ADDENDUM NO. 1

Additions & Renovations to Pleasant Run Elementary School
1800 North Franklin Road
Indianapolis, IN 46219

PROJECT: PLEASANT RUN ELEMENTARY SCHOOL RENOVATION & ADDITION

PROJECT NO: 2020061

DRAWING NUMBER
C501

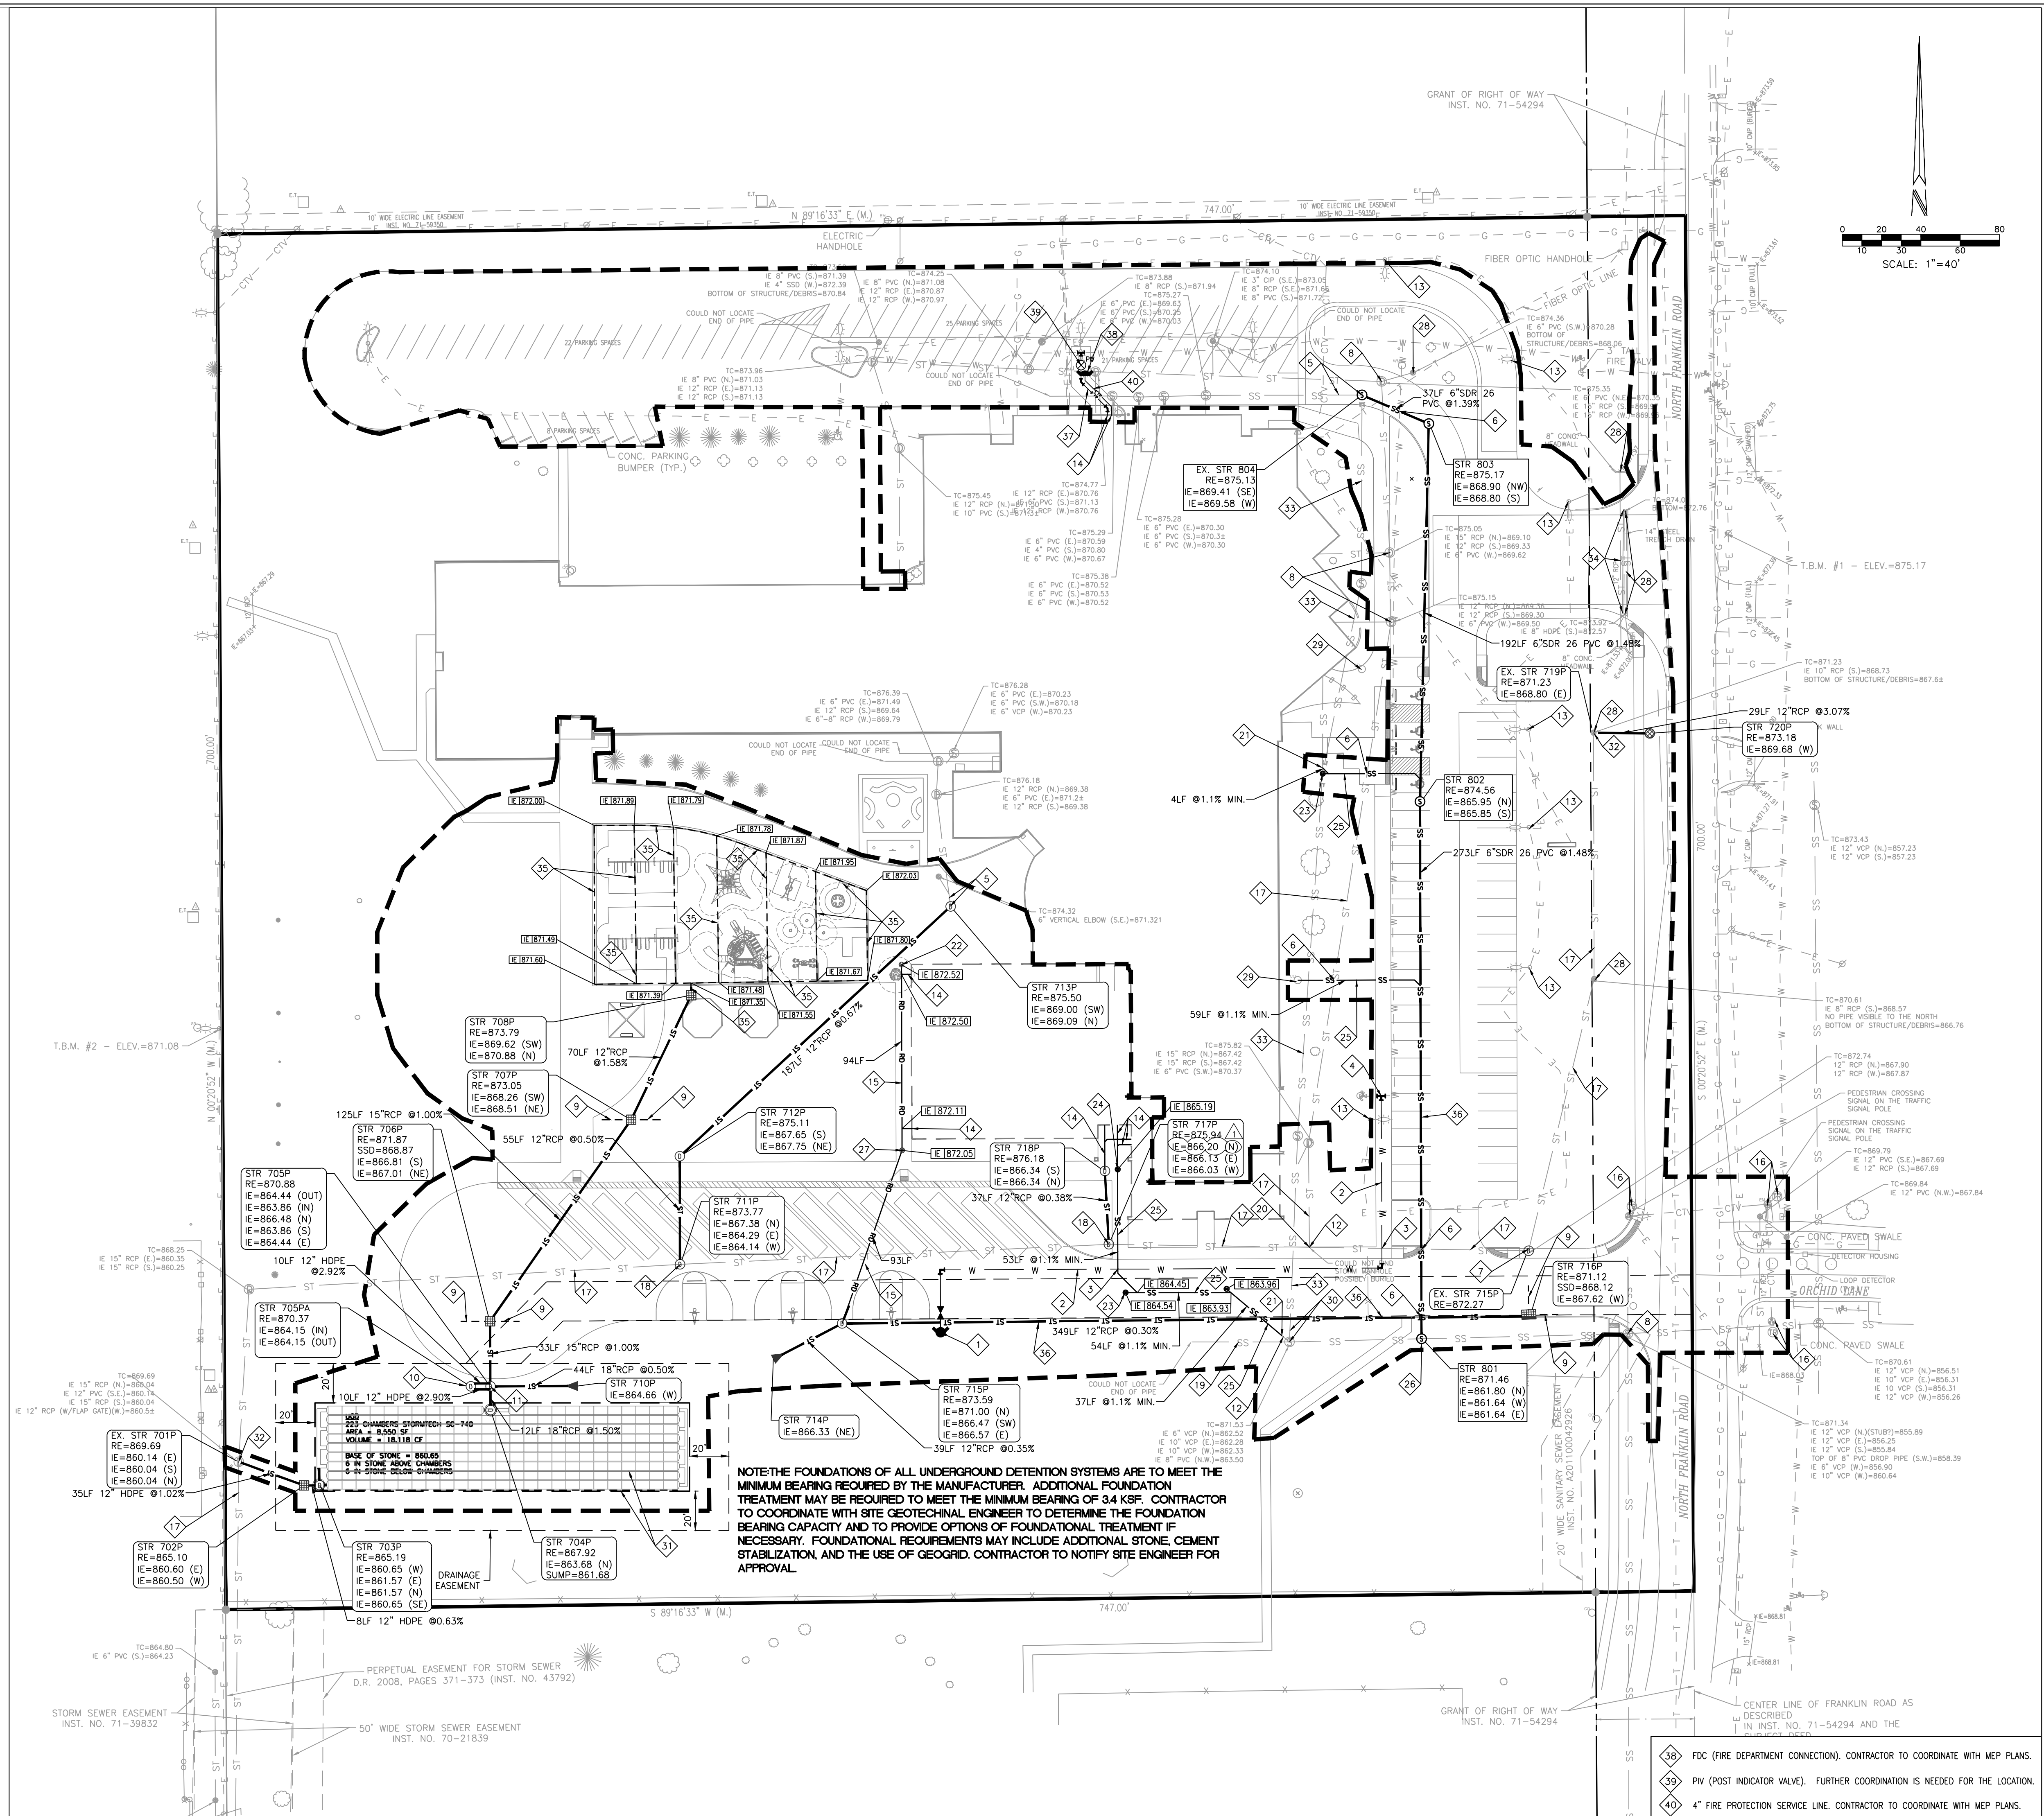
4. C501 Utility Plan
 - a. Revise pipe invert at structure 717P.
5. C502 Utility Details
 - a. Revise Diversion structure detail.
 - b. Revise structure data table.

DRAWING NUMBER
C503

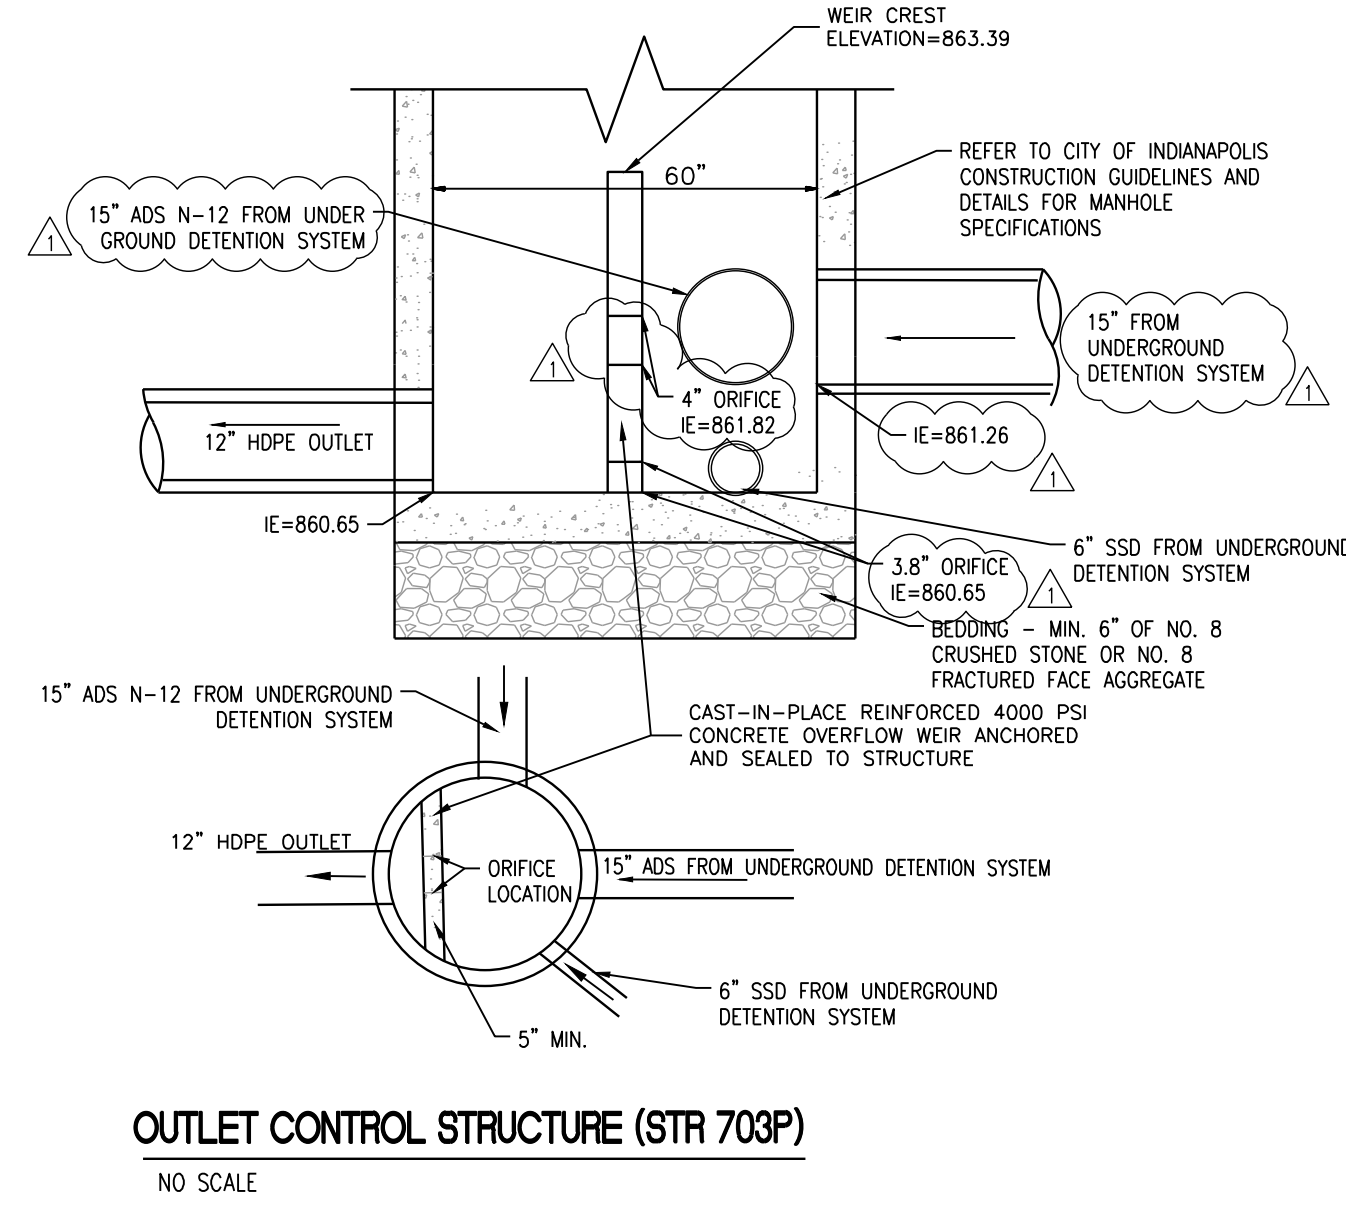
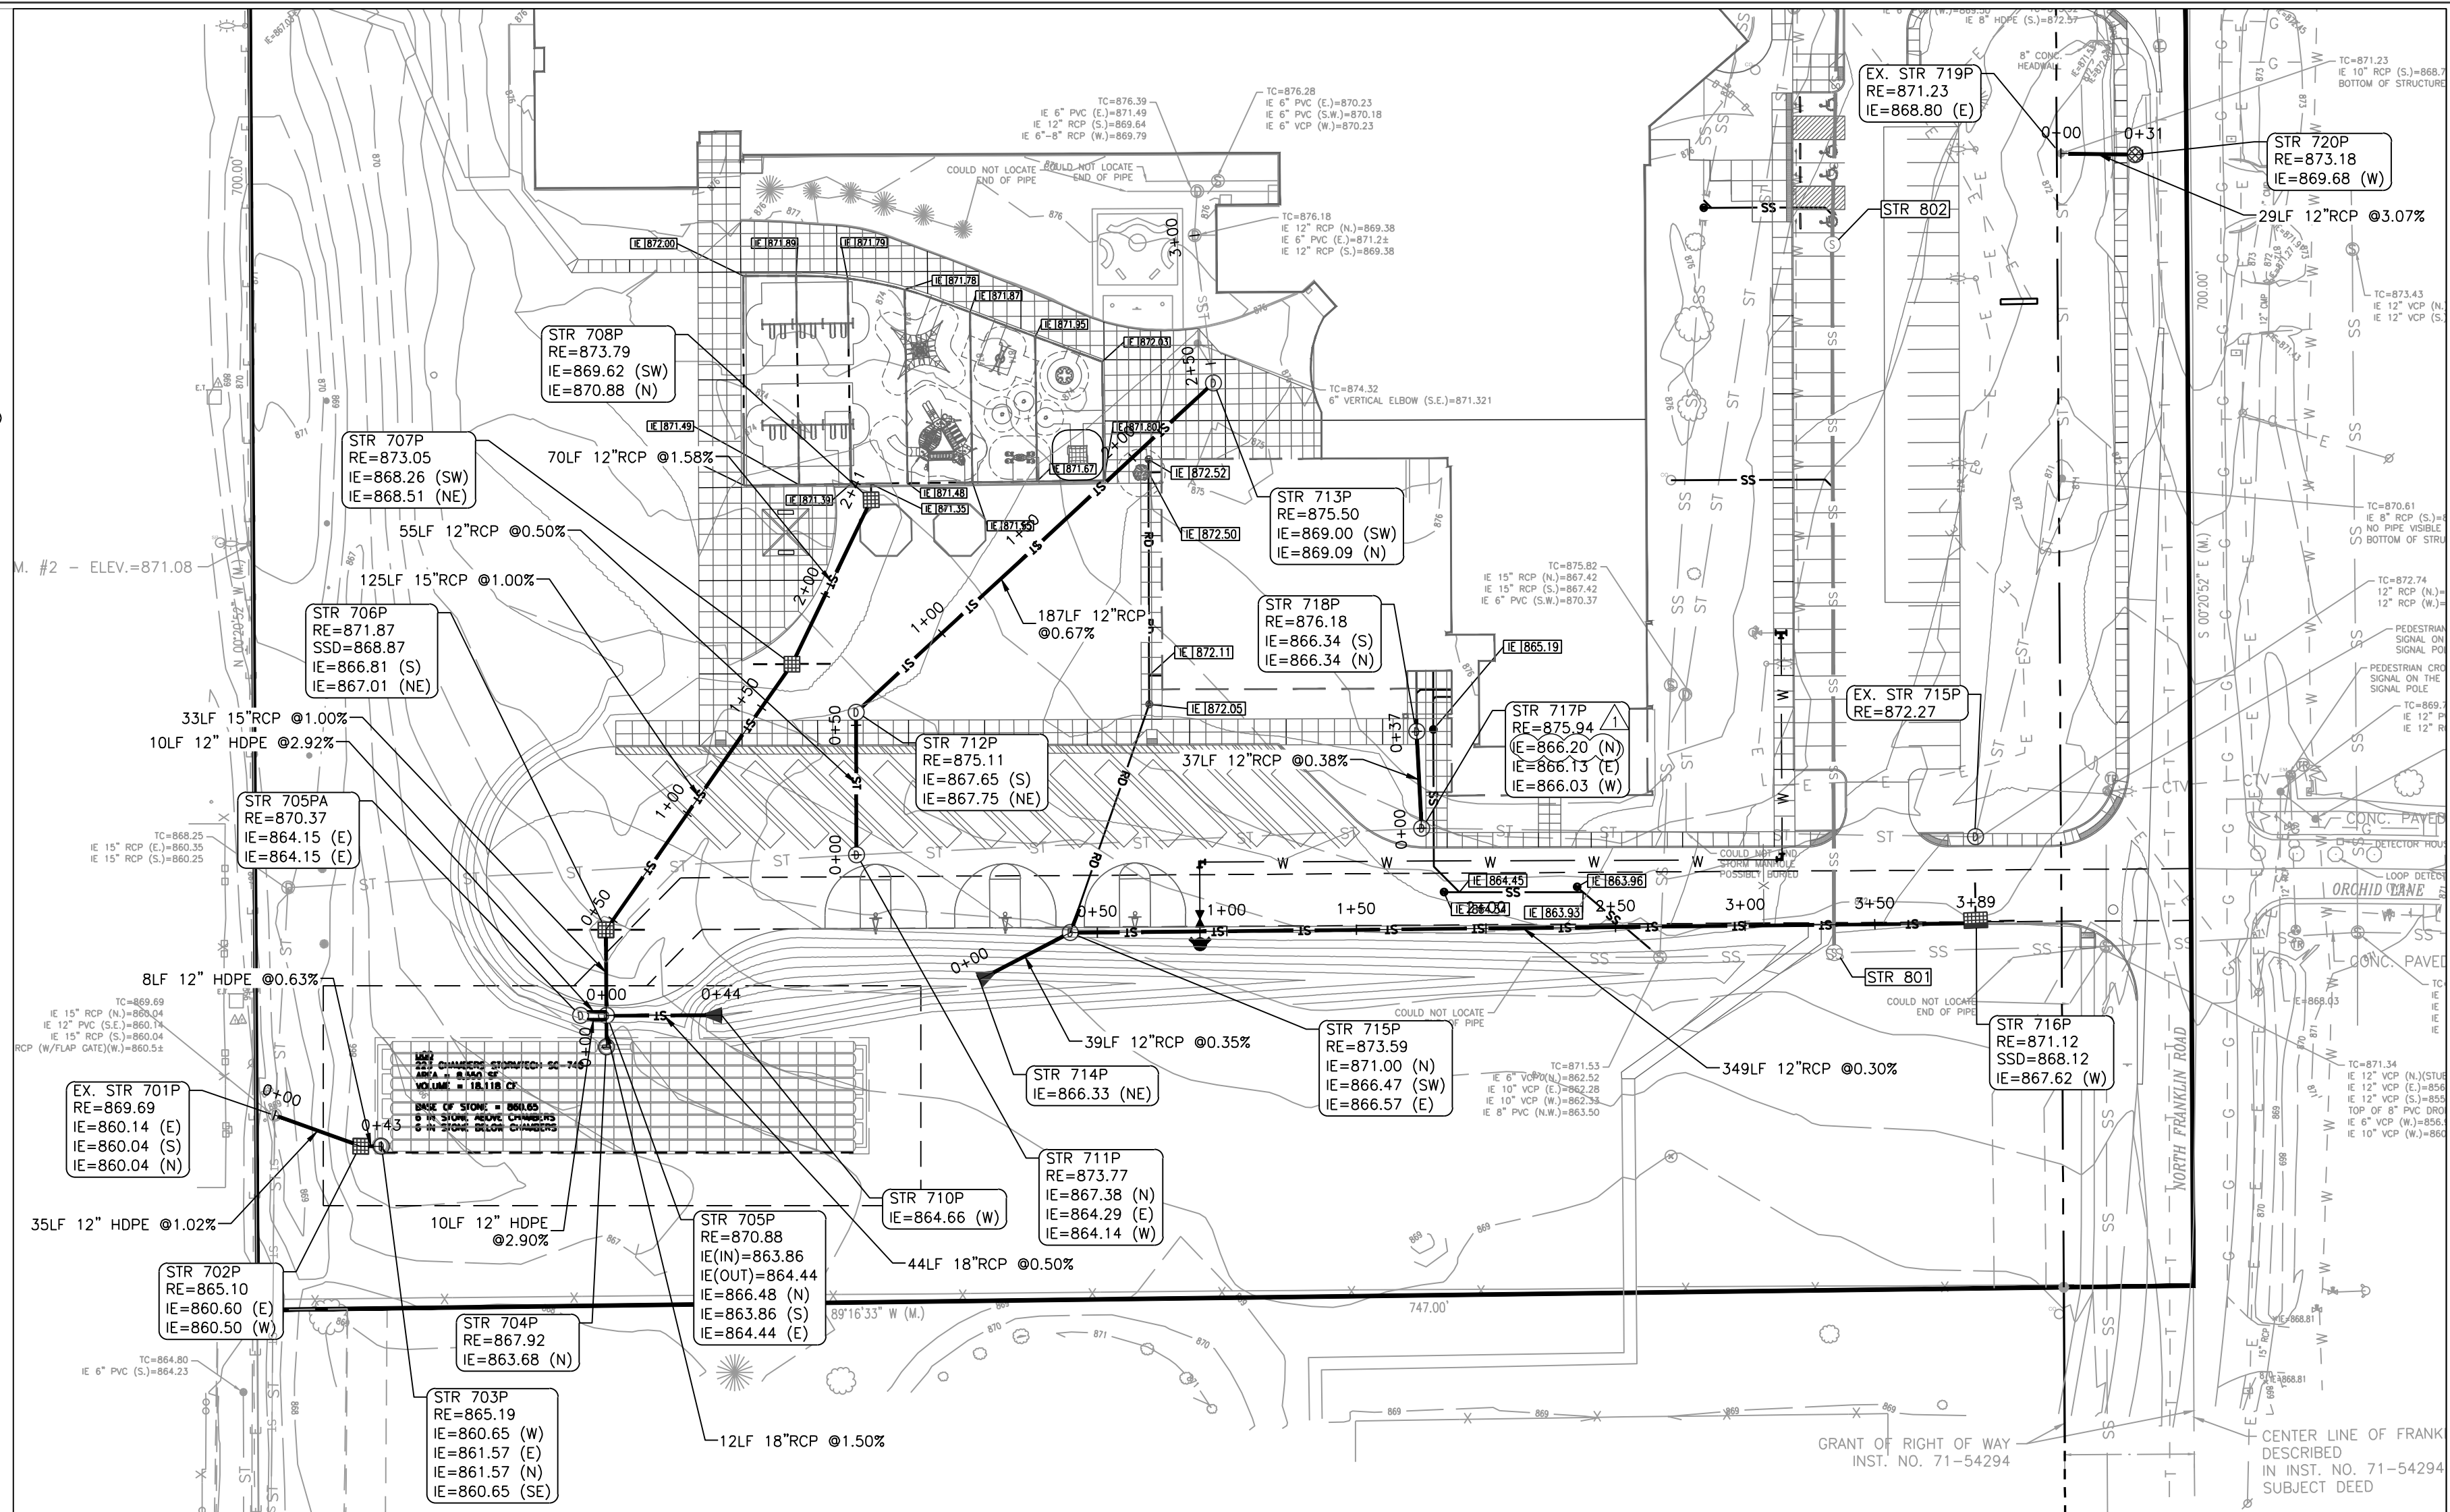
6. C503 Utility Details
 - a. Revise Outlet Control Structure Detail.
 - b. Add ADS details
7. New sheet C504 Utility Details
 - a. Add ADS details for the underground detention system.
